COVERING NOTE

Subject: Erratum 1 (07/2016) to Recommendation ITU-T G.9701 (2014), *Fast access to subscriber terminals (G.fast) - Physical layer specification*

2) Figure 7-1

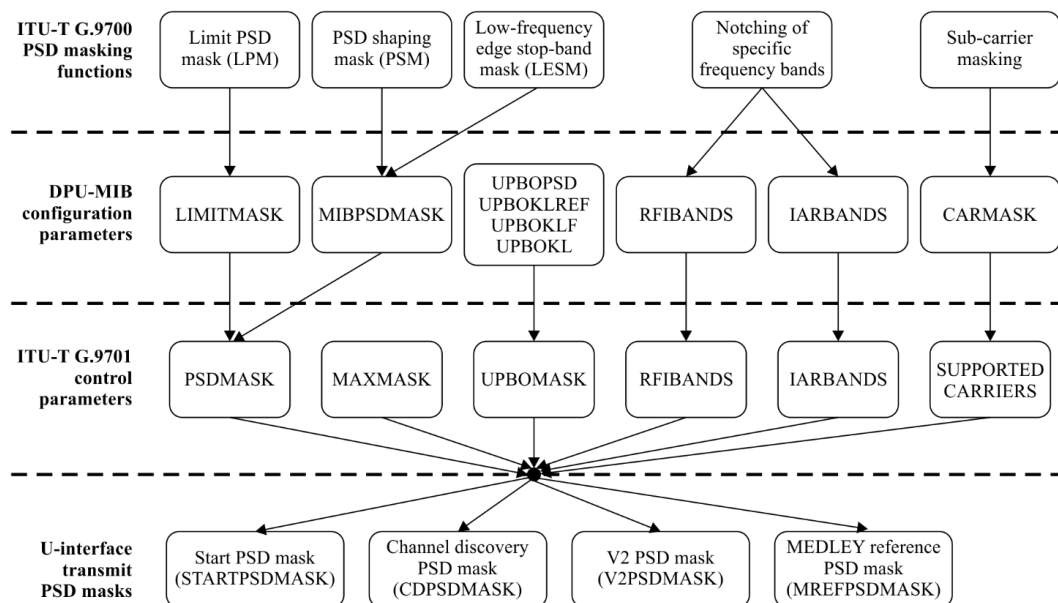
In Figure 7-1, replace "ITU-T G.970 control parameters" should read "ITU-T G.9701 control parameters". Replace Figure 7-1 with the following figure:
